Number	N.4
Section	Body and Exhaust System
Sheet	1 (of 1)
Date	May, 1960

PAINT COLOURS

RUBBER DOOR BUFFERS

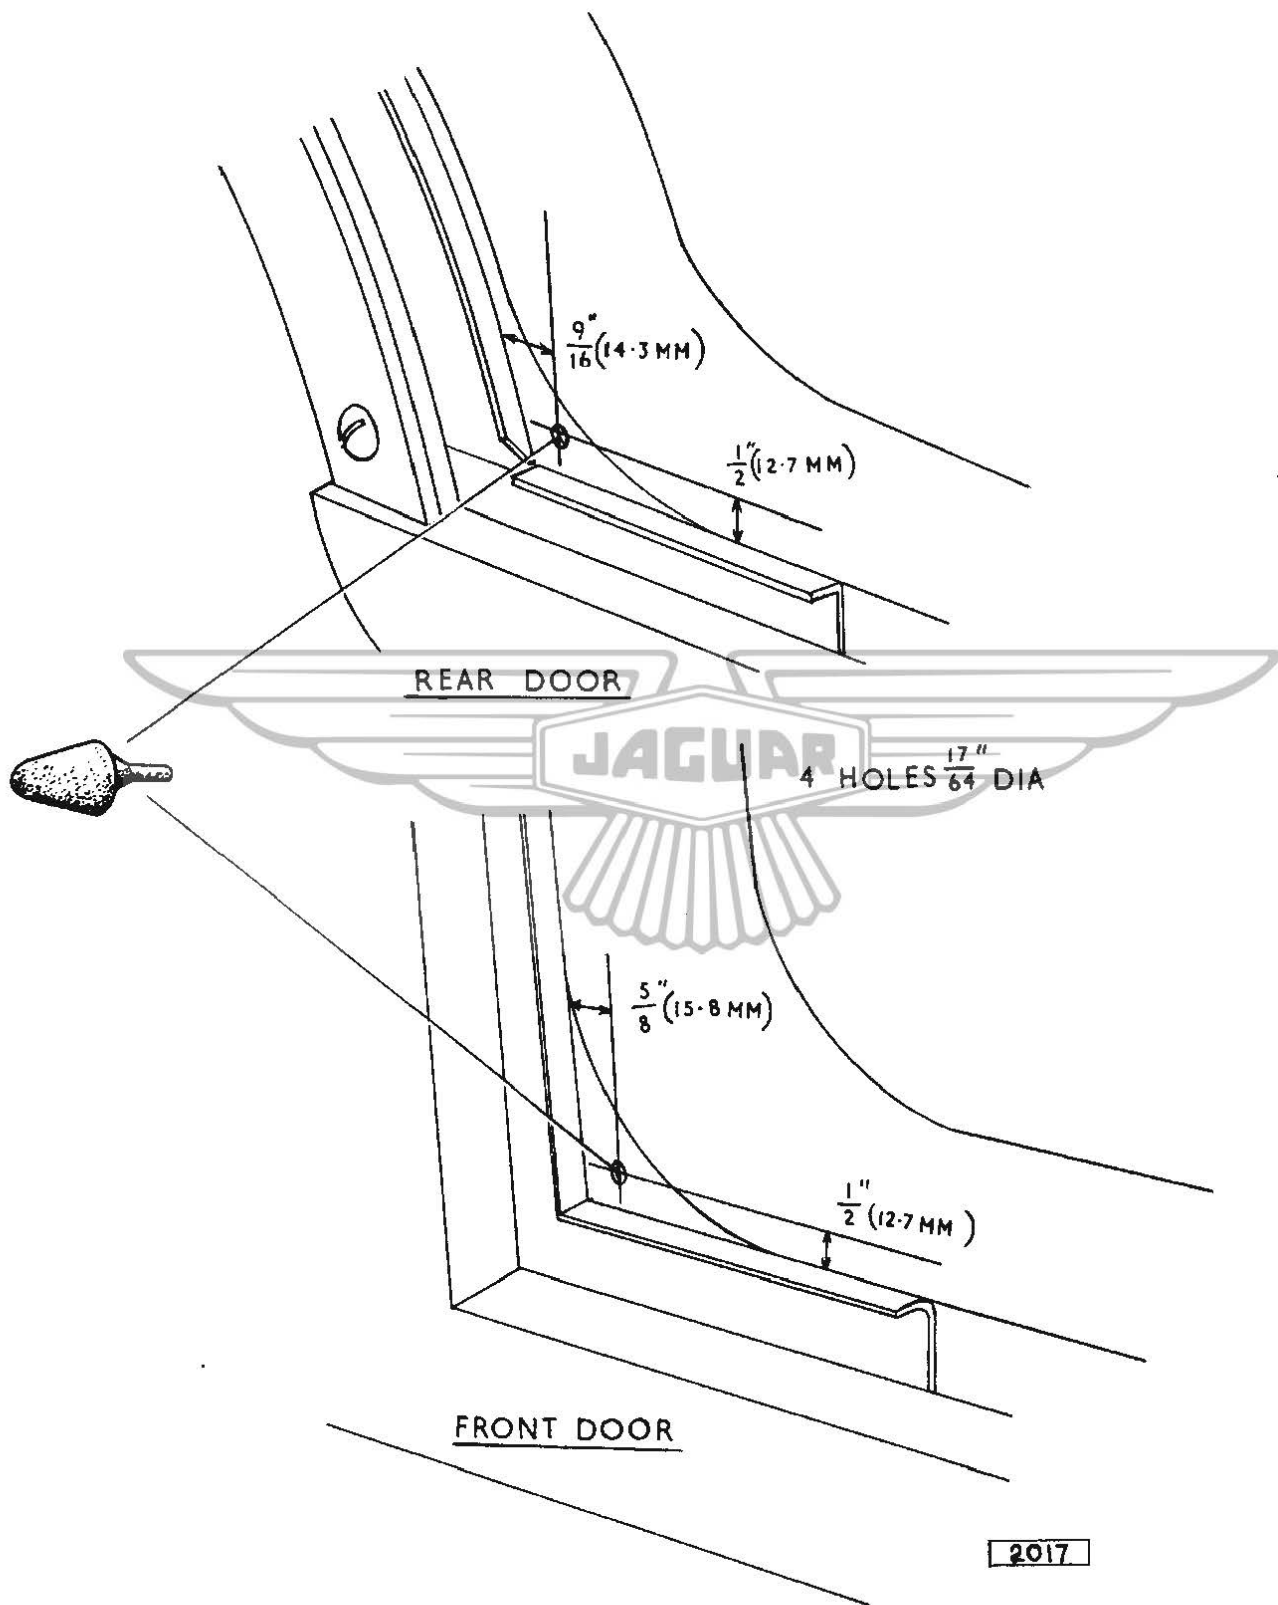
On cars with the above chassis numbers and onwards, a rubber buffer (Part number BD.4951) is fitted to the outer rear corner of the front and rear door sills to eliminate movement of the doors when shut.

Interchangeability is not affected by the introduction of the buffer which may also be fitted to cars prior to the above chassis numbers if desired. To incorporate this modification on such cars, it is necessary to drill a 17/64" (6.74 mm) hole in the door sills as shown in the illustration overleaf. It may be necessary to reduce the height of the buffer to ensure a perfect fit.

BONNET LOCK - MODIFIED TYPE

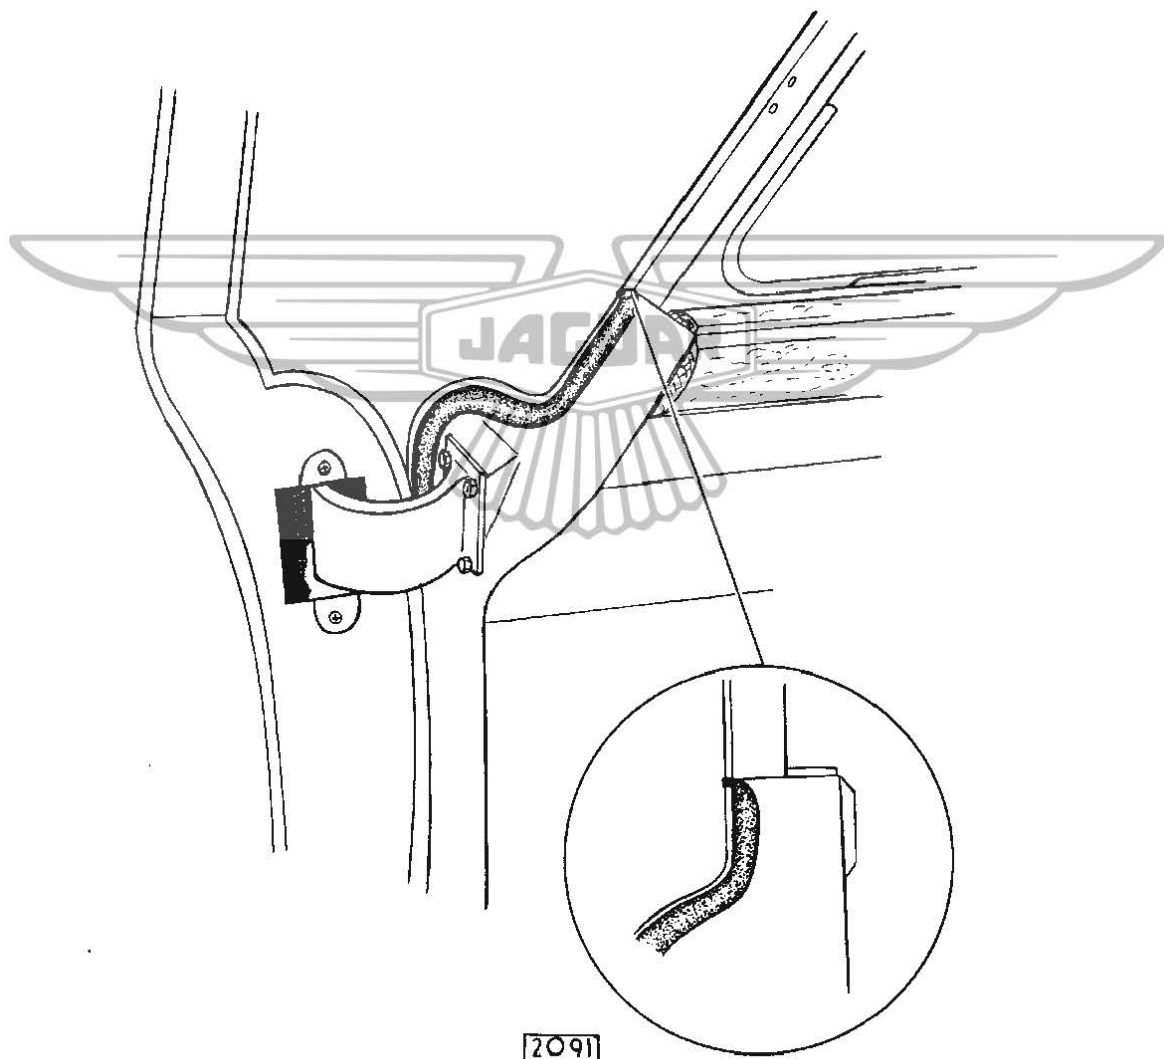
On cars with the above chassis numbers and onwards, a revised bonnet locking system is incorporated. The bonnet is fastened and released by means of two small levers one on either door hinge pillar.

To open the bonnet, turn the levers anti-clockwise and pull out to their full extent. Insert the fingers under the rear edge of the bonnet, press in the safety catch and raise the bonnet. To close the bonnet, push the bonnet closed, then applying pressure to the top of the bonnet, push the lever fully home and turn clockwise. Repeat for the other side of the bonnet. It is MOST IMPORTANT to ensure that the levers are out to their full extent and have not been pushed in accidentally before attempting to close the bonnet or the bonnet may be damaged.

SEAT BELT ATTACHMENT POINTS

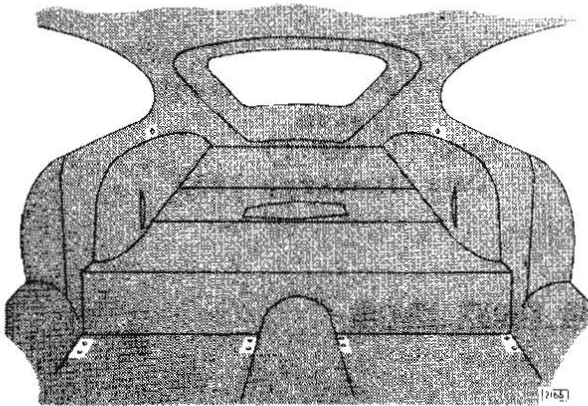
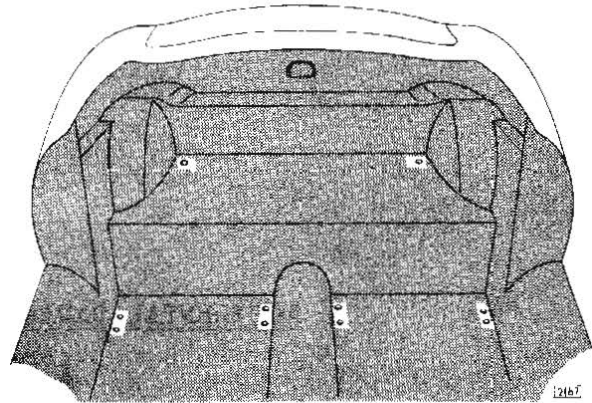
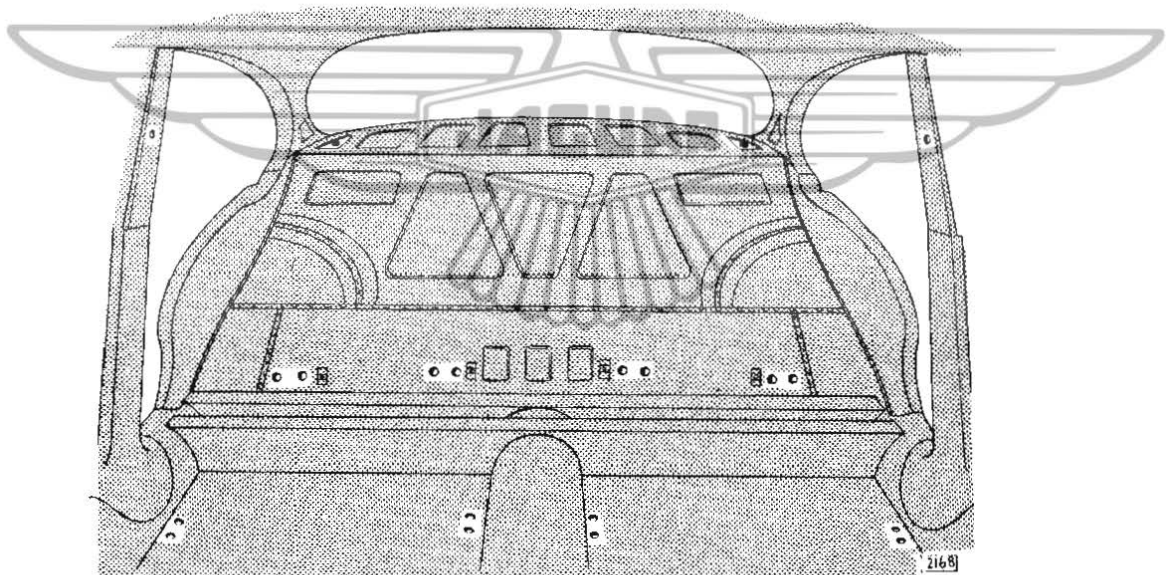
On cars with the above chassis numbers and onwards, mounting points for the attachment of seat belt anchor brackets are provided. The mounting points are in the positions shown overleaf and are designed to suit a wide range of seat belt types. The pairs of holes for floor mountings are $2\frac{1}{2}$ " (6.35 cm) between centres, one hole being a $\frac{3}{8}$ " (9.5 mm) plain clearance hole and the other being a $7/16$ " (11.1 mm) UNF tapped hole. The mountings holes behind the seats or on the centre pillars are all tapped $7/16$ " (11.1 mm) UNF. (See illustrations overleaf).

On cars supplied to North America, eye bolts are fitted to the tapped holes on the floor mountings behind the front and rear seats.

JAGUAR SEAT BELTS.

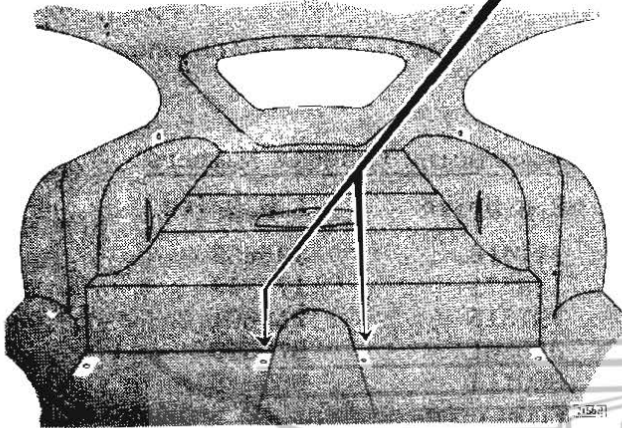
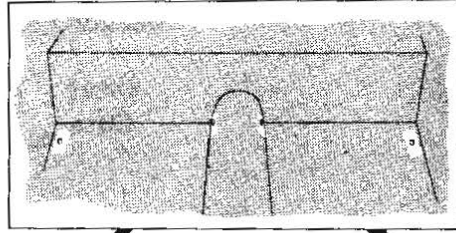
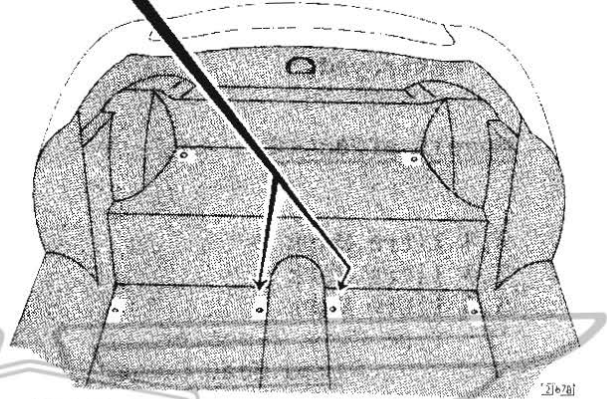
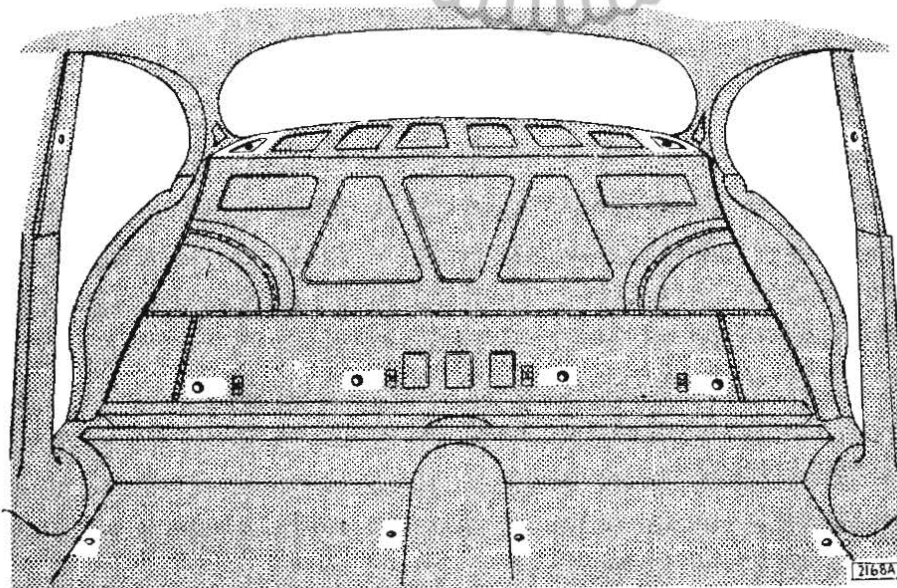
The positions of the anchorage points are shown overleaf. Earlier cars had two holes, one plain and one tapped, at the floor anchorage positions; later cars have only a single 7/16" (11.1 mm) U.N.F. tapped hole. In either case only the tapped holes will be used for anchorage purposes.

Note: The tapped holes in the floor are blanked off with plastic cross headed screws. On the Mark 2 and Mark 10 models, the tapped hole in each centre pillar is blanked off with a chrome plated escutcheon.

INSTRUCTIONS FOR FITTING RECLINING MECHANISM.

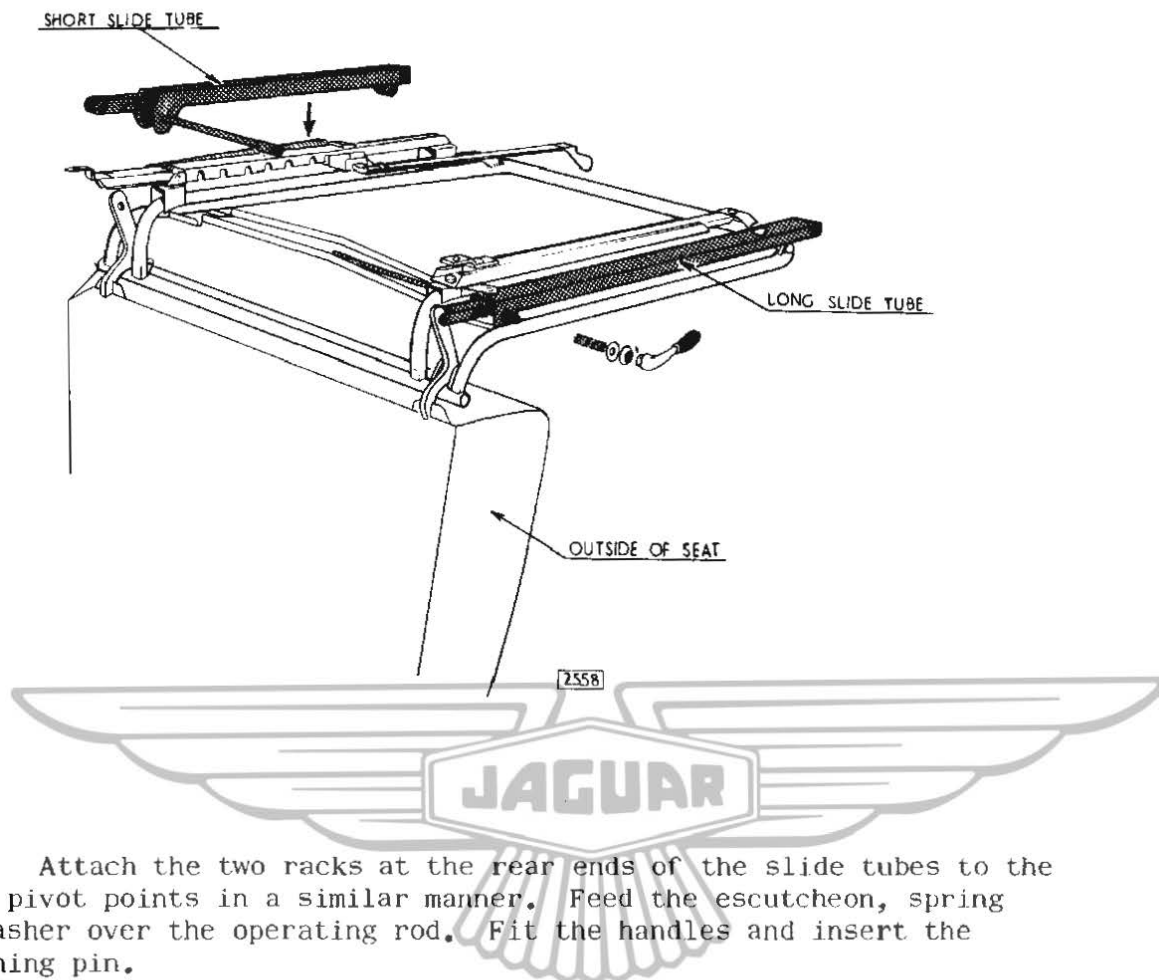
Commencing at the above chassis numbers, the front seats of Mark 2 cars can be converted to the reclining type.

Remove the tie rods (2 per seat) locking the seat base to the squab, after extracting the setscrews, nuts, and washers. (see illustration overleaf)

Check that the rack protrudes from each slide tube assembly by an equal amount. Adjust if necessary by turning one of the operating lever rods and releasing the rack pawl.

Attach the inner (short) slide tube assembly to the seat base front pivot with a clevis pin and three brass washers, locating two washers between the lugs on the tube assembly and the seat base and the remaining washer under the split pin.

Repeat the operation to the outer (long) slide tube assembly ensuring that the two halves of the operating rod centre coupling are mated correctly.

Attach the two racks at the rear ends of the slide tubes to the squab pivot points in a similar manner. Feed the escutcheon, spring and washer over the operating rod. Fit the handles and insert the retaining pin.

NOTE: The handles are handed and must be fitted with the lever knob towards the front and curving downwards. Lubricate all pivot points with oil and coat the racks lightly with grease.

INSTRUCTIONS FOR FITTING RECLINING MECHANISM
TO SPECIAL ADAPTABLE TYPE FRONT SEATS.

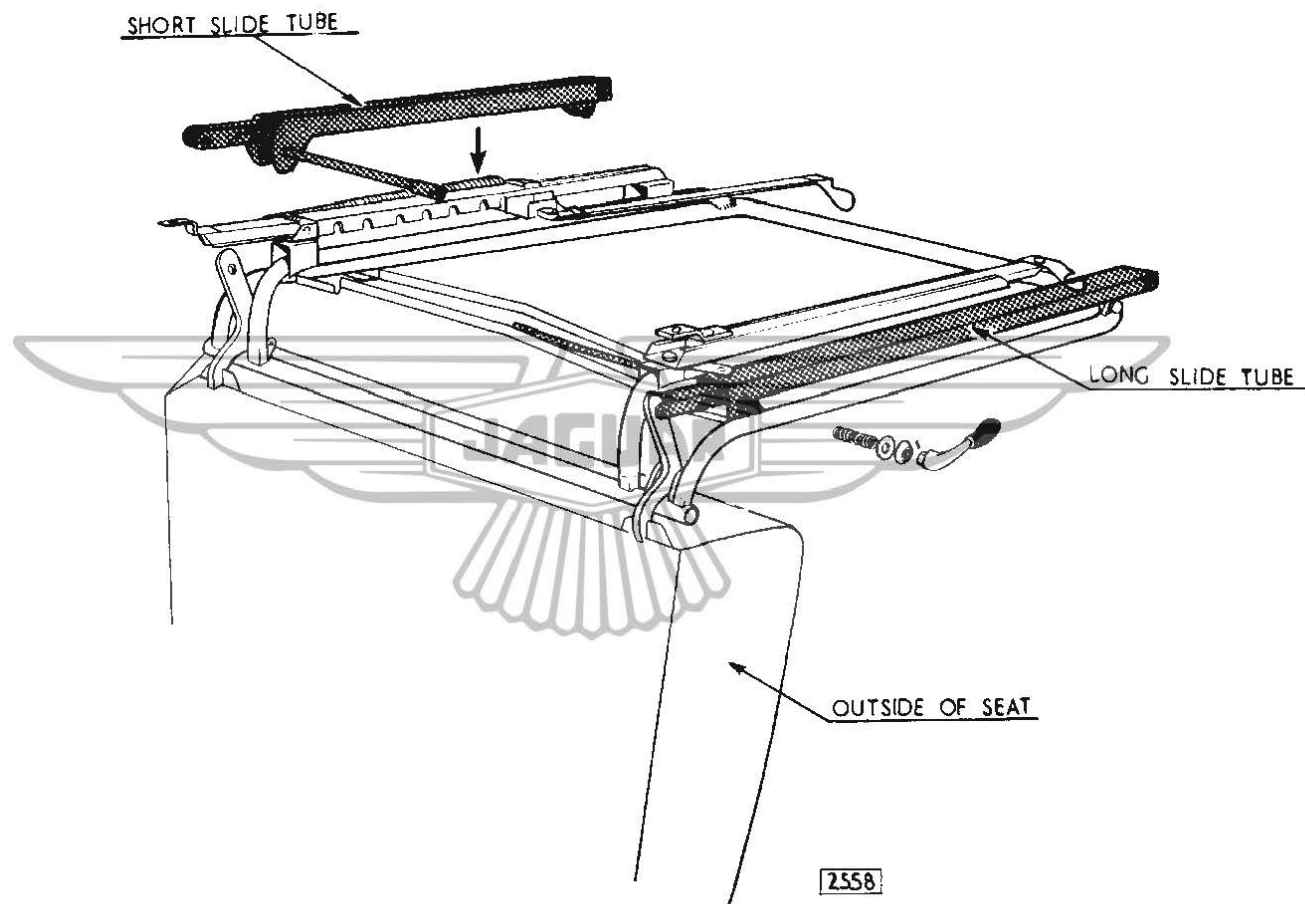
Remove the tie rods (2 per seat) locking the seat base to the squab, after extracting the setscrews, nuts and washers (see illustration).

Check that the operating rods will pass through the pivot holes in slide tube brackets.

Attach the lock spring to the locking lever. Fit the spring with the square loop over the top of the lever and the circular loop passing under the lever pivot bosses.

Feed the lever between the slide tube brackets and hook the spring into the two small holes.

Line up the lever with the holes in the bracket and insert the operating rod as shown in the illustration.

Secure the lever to the operating rod with an Allen headed grub screw ensuring that the screw registers with the ident in the rod.

Raise the lever and trap in the raised position with a screwdriver.

Insert the correct spring and follow with the rack. Force the rack against the spring into the slide tube until only five slots are visible. Remove the screwdriver and lock the rack in this position.

WARNING: DUE TO THE RACK BEING UNDER CONSIDERABLE SPRING PRESSURE, DO NOT RAISE THE LOCKING LEVER BY TURNING THE ROD UNTIL THE ASSEMBLY OF THE SEAT IS COMPLETED.

FIG.1 THE SEAT BELT FITTED

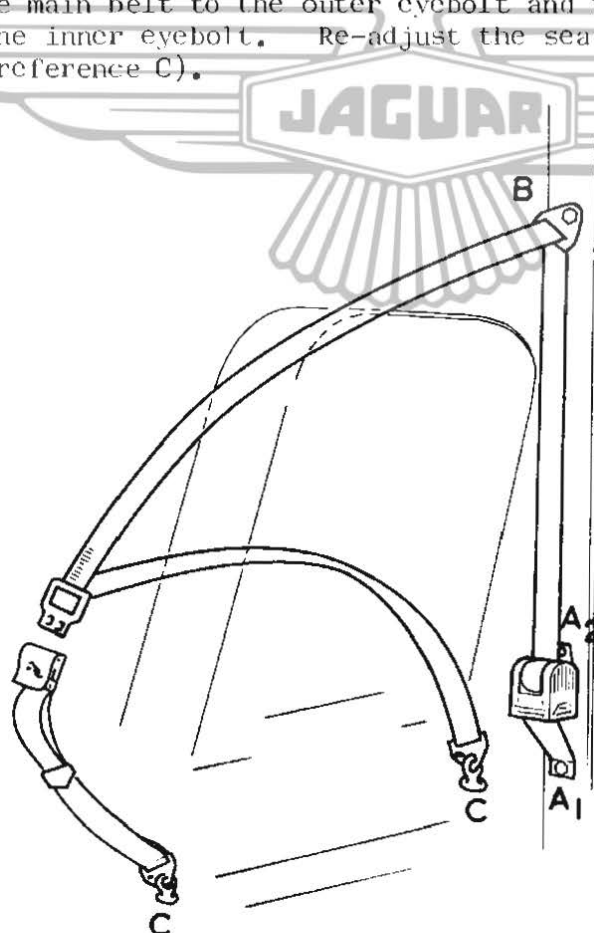
- (13) Attach the main belt to the outer eyebolt and the short (buckle) belt to the inner eyebolt. Re-adjust the seat position. (Fig. 1, reference C).

FIG.2 MOUNTING POINTS A₁ & A₂

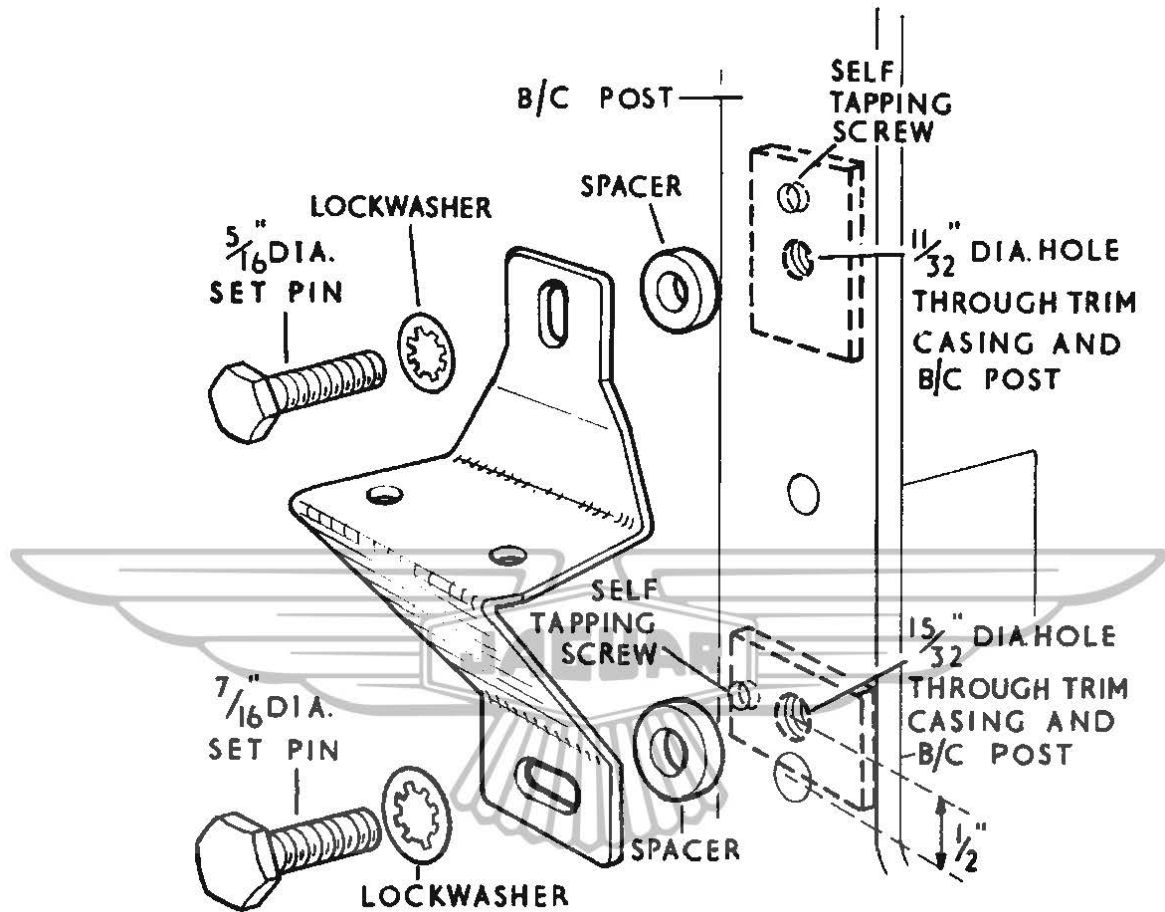
- (9) Attach the reel to the bracket with the two 5/16" setscrews, nuts and lockwashers. Note that the unit must be fitted so that the strap unreels against the back of the bracket. Attach the mounting bracket to the 'B/C' Post with the 5/16" and 7/16" setscrews, plain and lockwashers; the two distance pieces supplied in the kit should be interposed between the bracket and the trimming (Fig. 2). Tighten the setscrews fully.
